# Section 73 - Supporting Document

35 Elsworthy Road

## **Basement Consented**

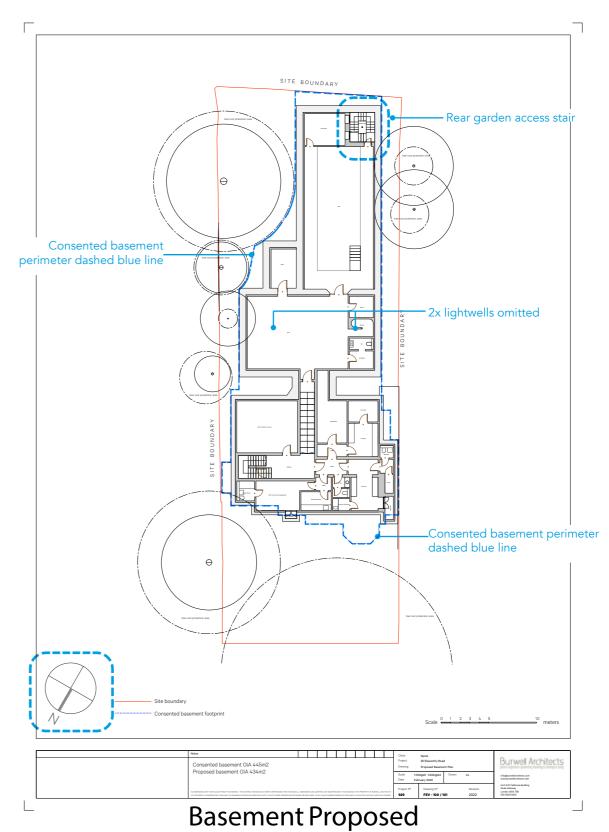
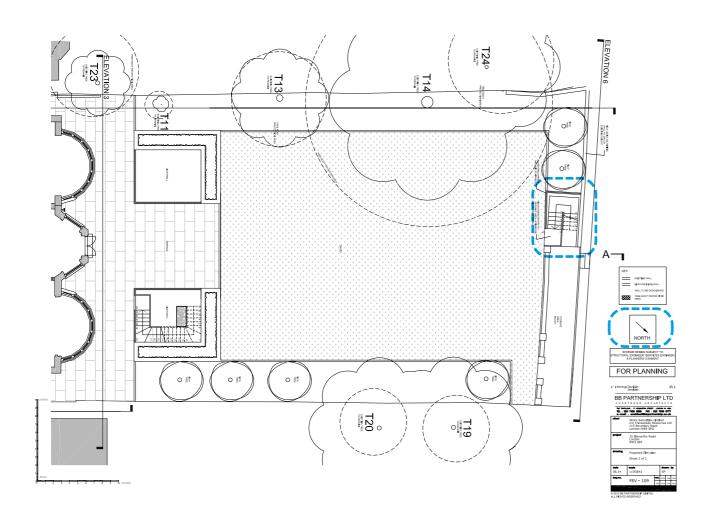
- North point incorrect
- Rear garden access stair should have been shown on this plan

- Reduced basement footprint
- Omission of garden lightwells
- Rear garden access stair relocated and reconfigured
- North direction corrected

Site Plan Consented

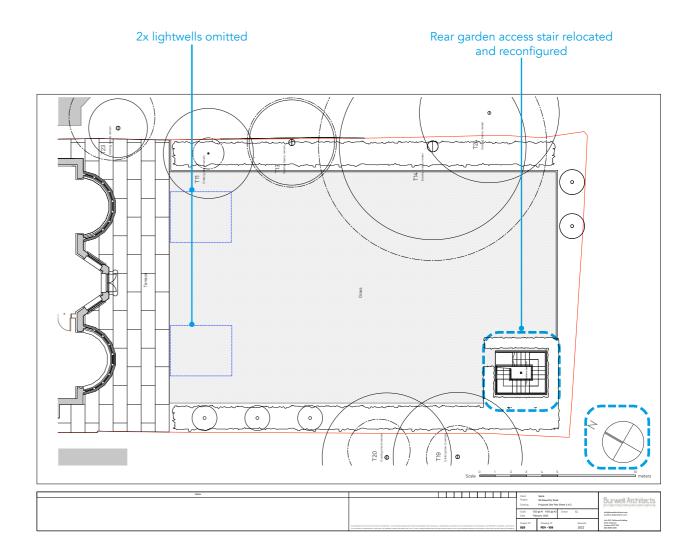
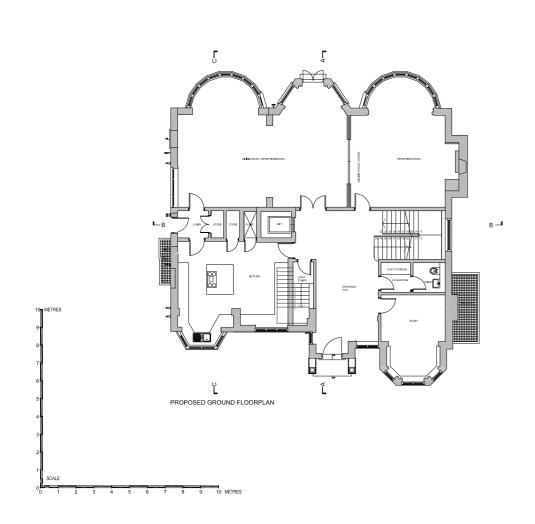
- North point incorrect
- Rear garden access stair is shown on this plan

- Omission of garden lightwells
- Rear garden access stair relocated and reconfigured
- North direction corrected

Ground Floor - Proposed

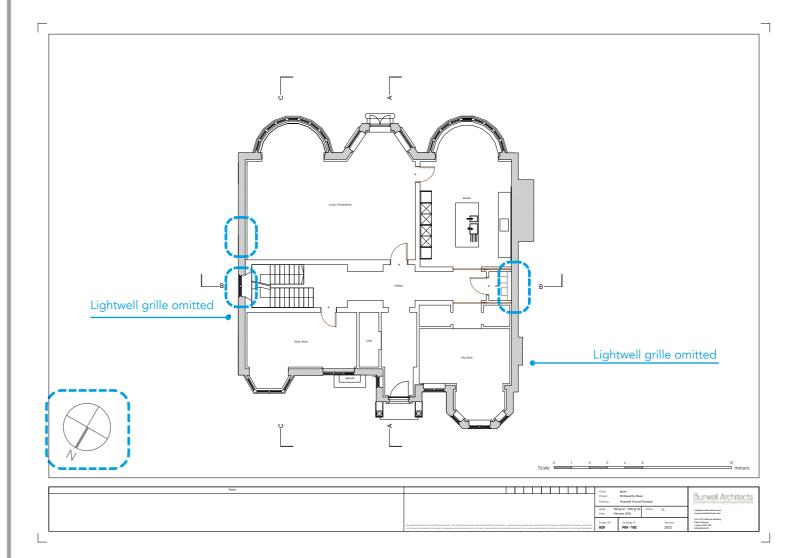
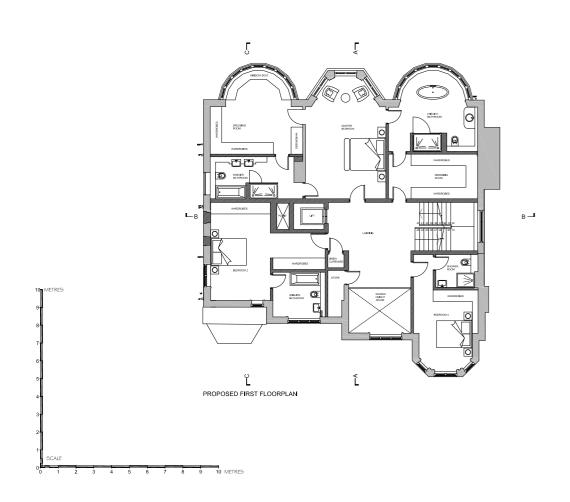
- Flank wall fenestration
- Internal arrangement
- Lightwell grille omitted
- North direction corrected

First Floor - Proposed

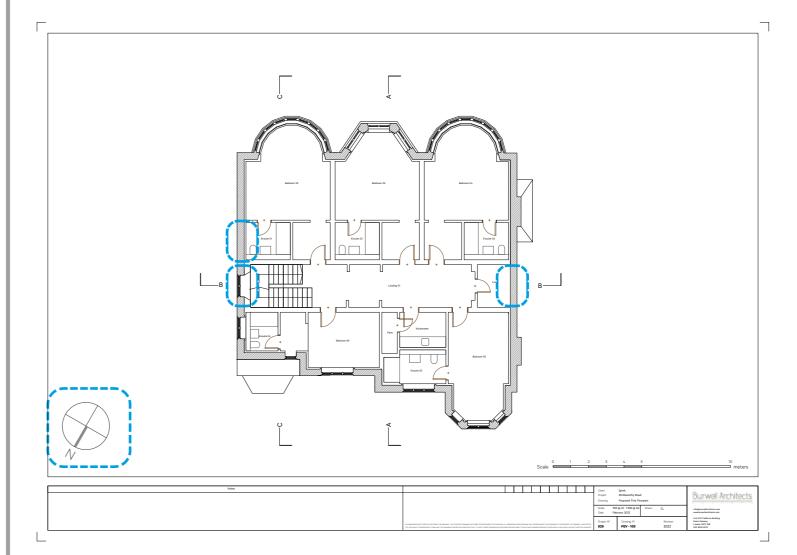
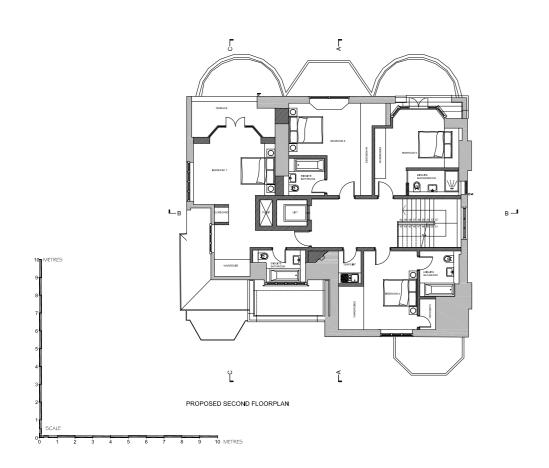
- Flank wall fenestration
- Internal arrangement
- North direction corrected

Second Floor - Proposed

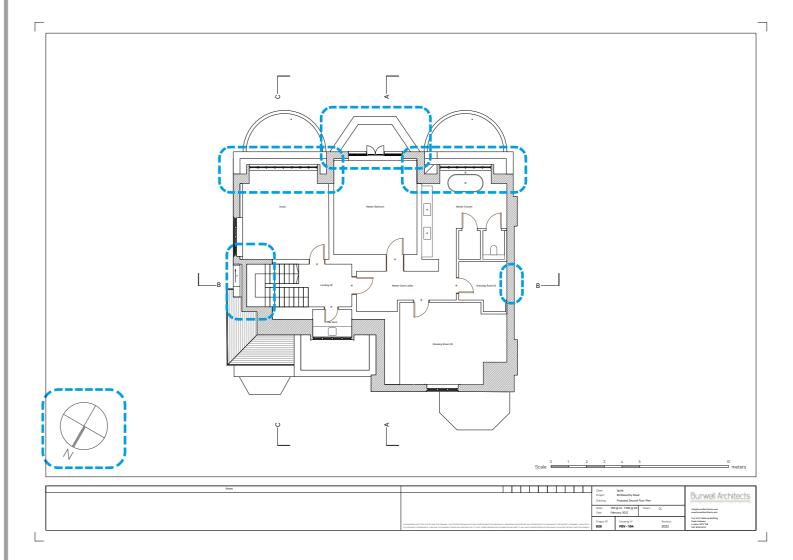
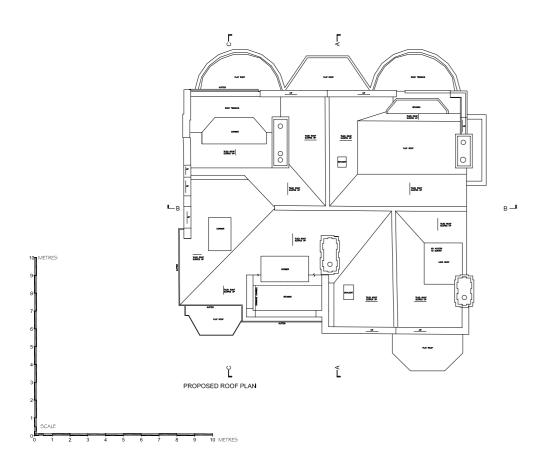
- Flank wall fenestration
- Rear dormers & central window modifications
- Central bay parapet modification (to match front) & central fenestration modifications
- Internal arrangement
- North direction corrected

Roof Plan - Proposed

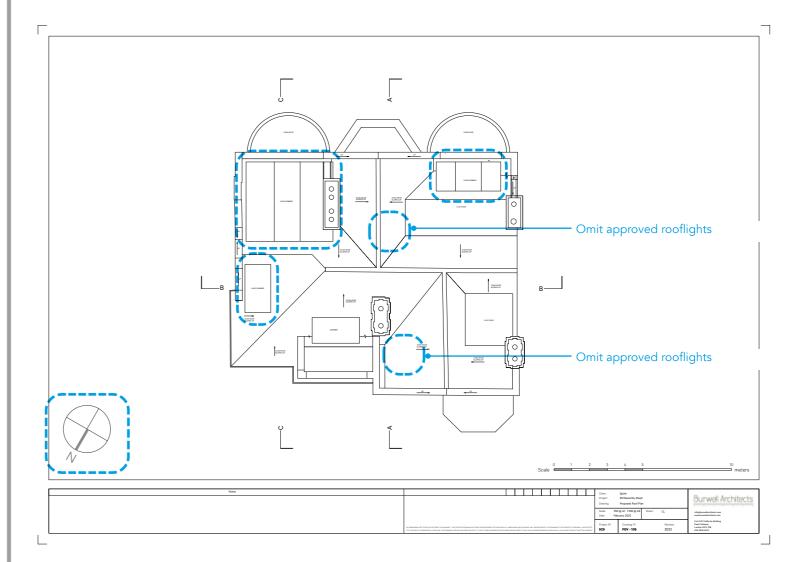
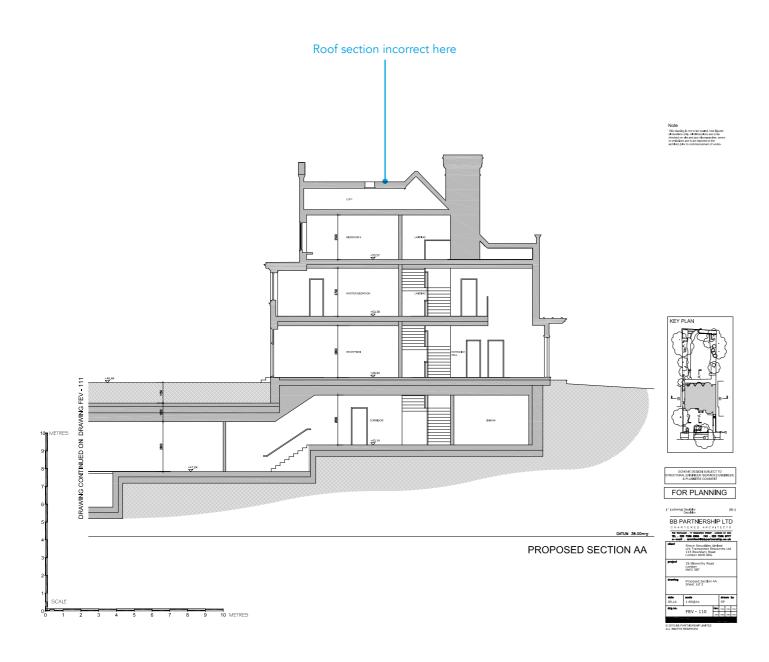
- Rear & side dormer modifications
- Rooflights omitted
- North direction corrected

Section AA - 1 of 2 - Proposed

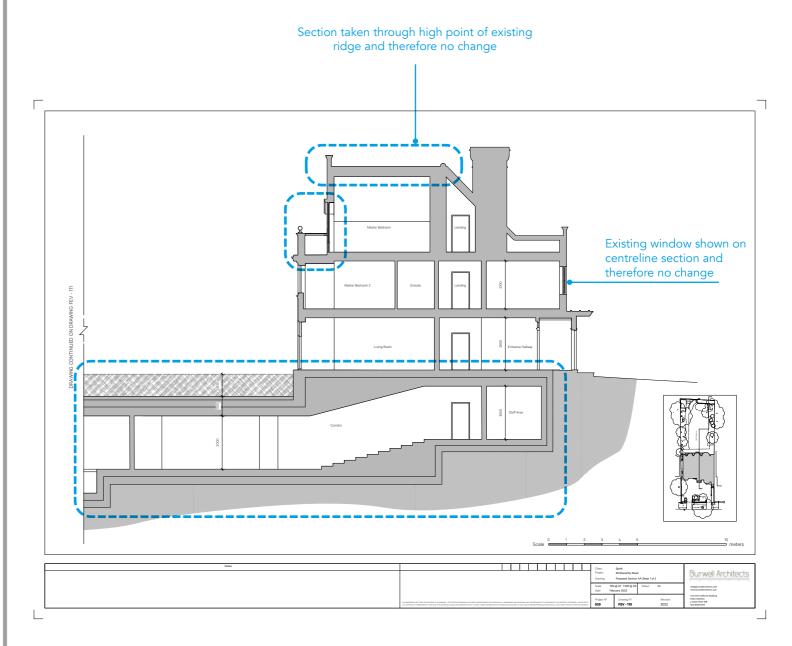
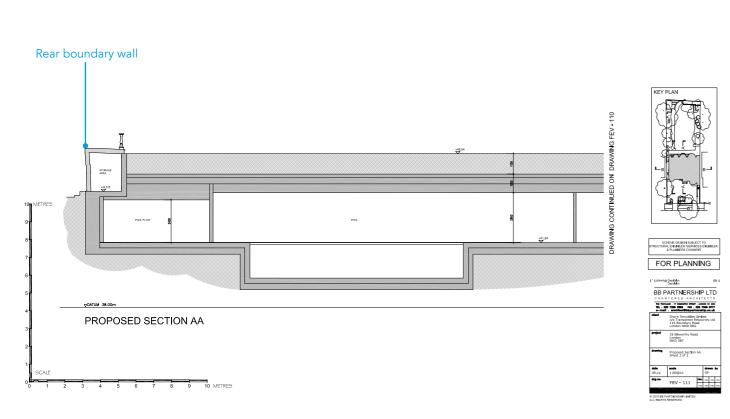
• Roof section / profile incorrect

- Basement footprint reduced
- Central bay parapet modification to match front (at 2nd floor)
- Roof section / profile correct
- Amended depth to basement by reducing depth of swimming pool; increasing soil cover; and improving headroom.

Section AA - 2 of 2 - Consented

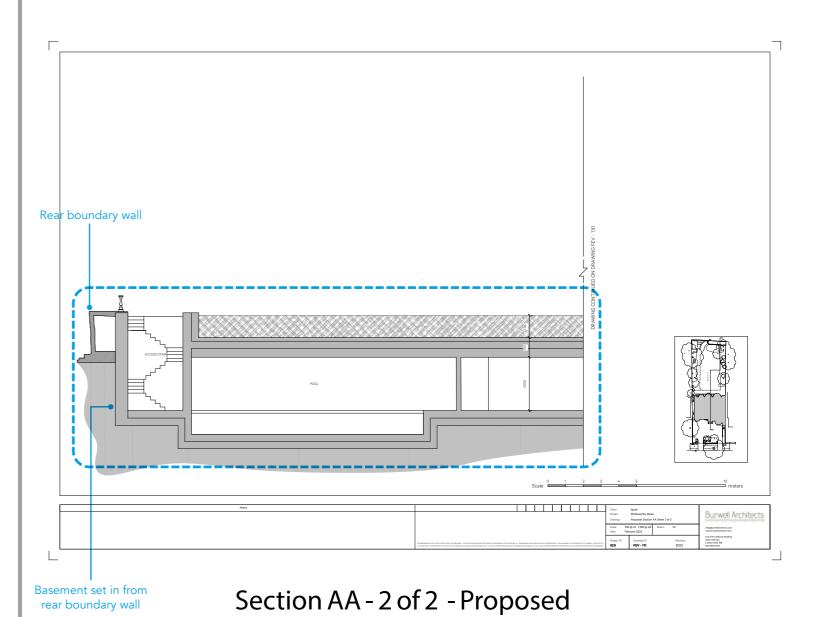
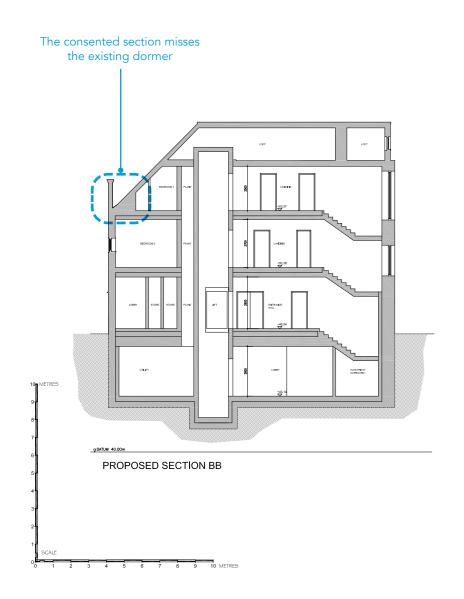
- Basement footprint reduced & set in from rear boundary wall
- Pool pit shifted within basement
- Amended depth to basement by reducing depth of swimming pool; increasing soil cover; and improving headroom
- Rear garden access stair relocated and reconfigured

Section BB - Proposed

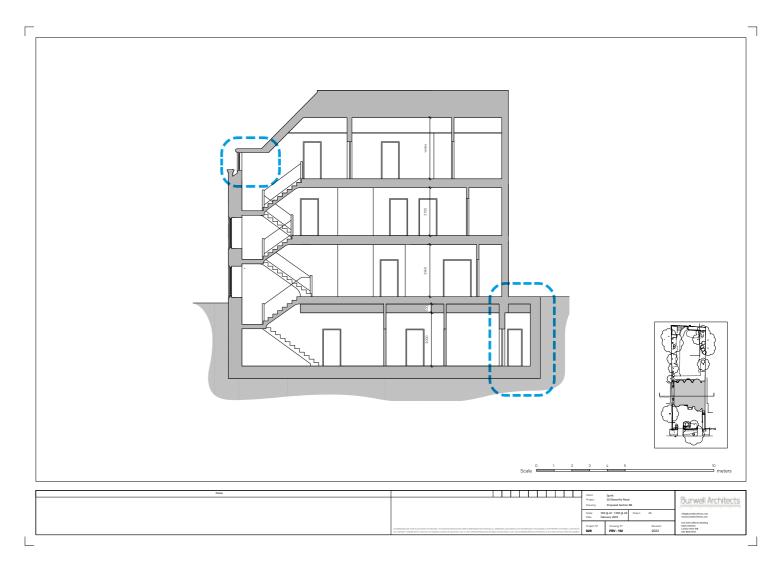
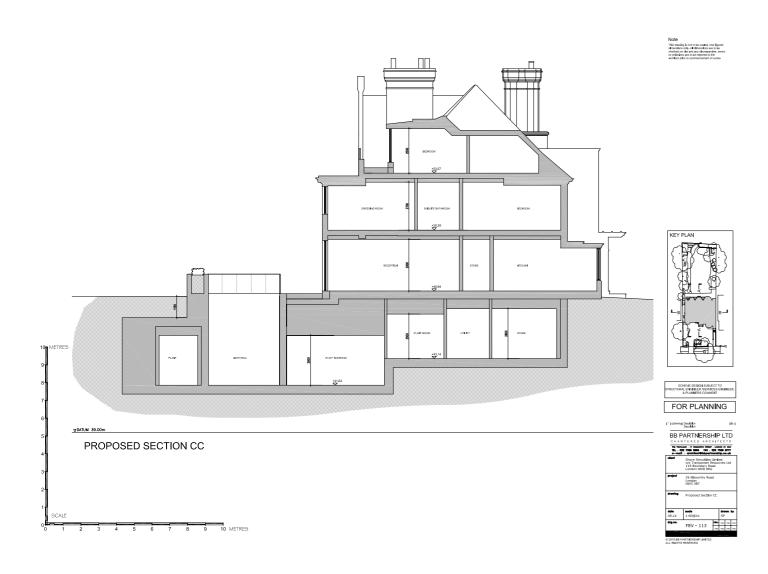
The Consented & Proposed Section BB's are taken on slightly different grid lines; the Proposed BB section cuts through the east dormer to explain the section clearly whereas the Consented grid line BB misses the existing dormer

- Side dormer modifications
- NB proposed Section BB to demonstrate (i) the east dormer window modification and (ii) the west consented basement lightwell which is proposed infilled as basement

Section CC - Proposed

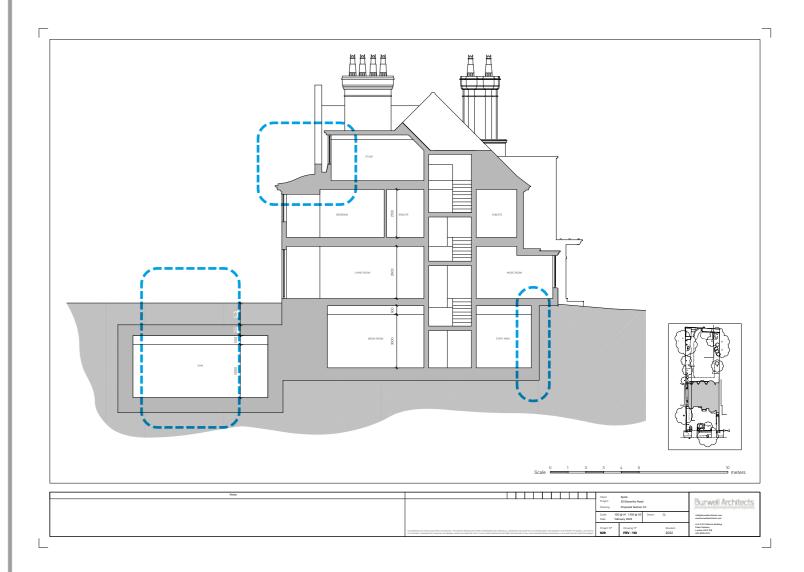
- Basement footprint slightly modified & omission of garden lightwells
- Rear & second floor dormer modifications

Elevation 03 - Proposed

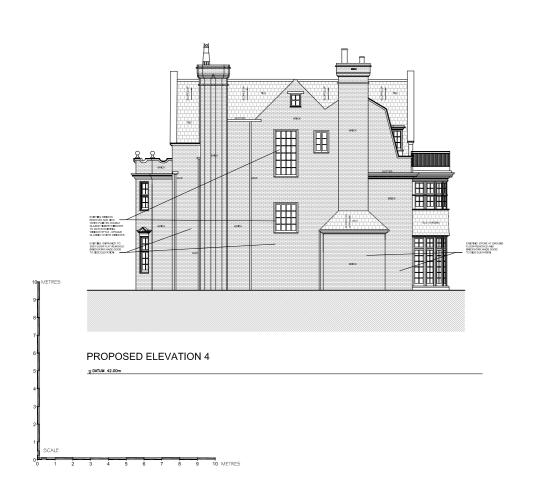
- Central 2nd floor window and bay parapet modification to match front
- Two rear bay lead roof modifications
- West and east rear roof dormers modified
- West ground floor bay window modifications

Elevation 04 - Proposed

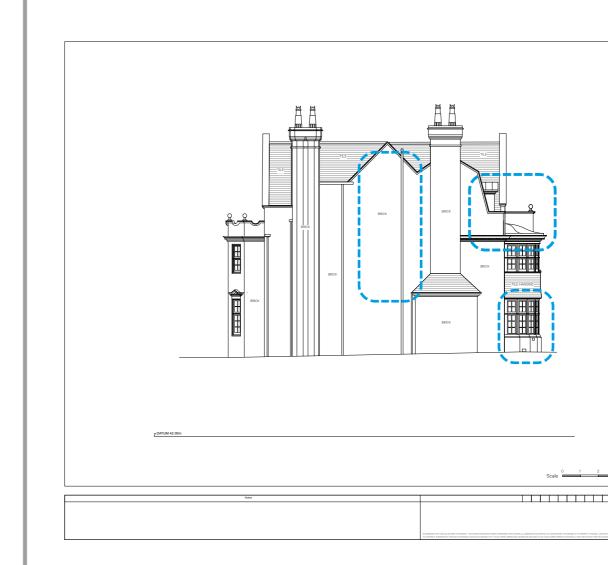
- Flank wall fenestration omission of various windows
- Rear dormer / 2nd floor modifications
- Bay window lead roof instead of metal balustrade balcony (to west bay window)
- West ground floor bay window modifications

Elevation 05 - Proposed

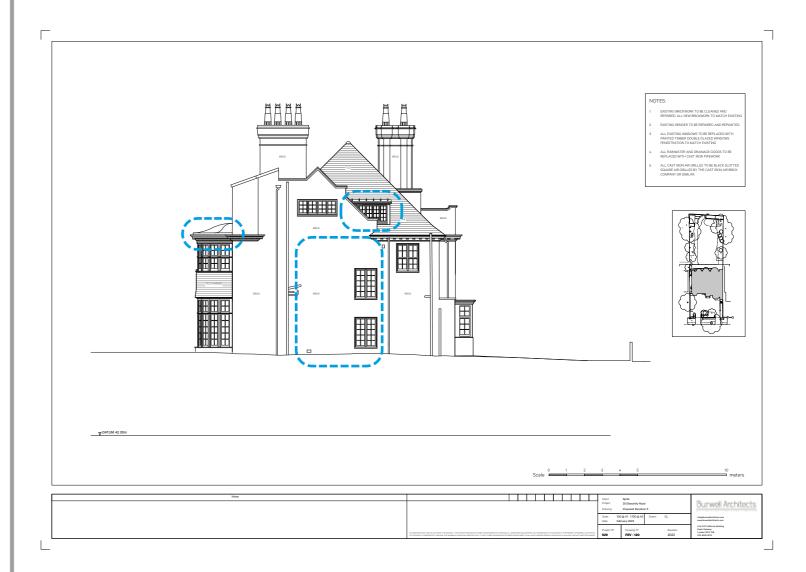
- Flank wall fenestration modified
- West side dormer and rear 2nd floor modifications
